APPLICATION NO.	FILING DATE	FIRST NAMED INVENTOR	ATTORNEY DOCKET NO.	CONFIRMATION NO.
09/817,669	03/26/2001	George J. Hudak	10003916-1	9797

# Office Action Summary

## **DETAILED ACTION**

U.S. Patent Nov. 13, 1984 Sheet 2 of 2 4,482,246

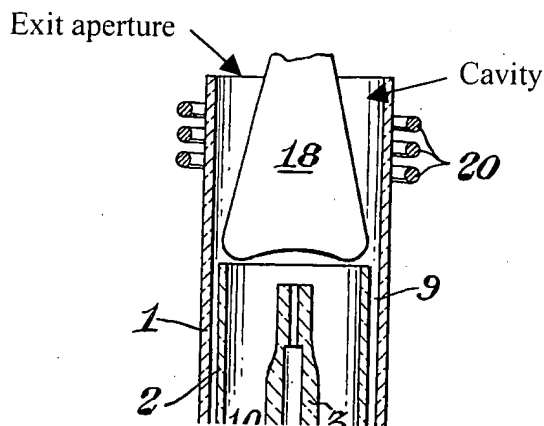
In regards to claims 1, 9, and 13, Meyer discloses in figure 2 and column 4 lines 34-43, an air-cooled gas discharge detector comprises a containing tube (1) that can be made from alumina, an air passageway (9) in contact with at least a portion of the outer surface of the gas

discharge tube, an entry aperture (8) for introducing air into the air passageway, an exit aperture (below) for allowing air to flow out of the air passageway, and an air source for supply a flow of air into the entry aperture for cooling the outer surface of the gas discharge tube.

Meyer is silent to the tube being made from sapphire.

However, it is well known in the art that alumina is any of several forms of aluminum oxide,  $\text{Al}_2\text{O}_3$ , including sapphire. It is further known in the art that sapphire is extremely resilient and a good conductor of heat, which allows for efficient cooling.

Therefore, it would have been obvious to one having ordinary skill in the art at the time the invention was made to construct the gas discharge detector of Meyer, including a sapphire gas discharge tube, since it is well known in the art that alumina is a form of sapphire which is extremely resilient and a good conductor of heat, which allows for efficient cooling.

In regards to claims 2-5, 12, 14-15, and 19-20, Meyer teaches all of the recited limitations of claims 1, 9, and 13 (above). Meyer further teaches in column 3 lines 3-10, that the discharge

(18) is powered by radio frequency source. Meyer further teaches in figure 2 that the radio frequency is introduced into a cavity (above), defined by an inner wall (3), two side walls (2) and an outer wall (1) and the air passageway extends alongside at least a portion of an exterior of the side walls.
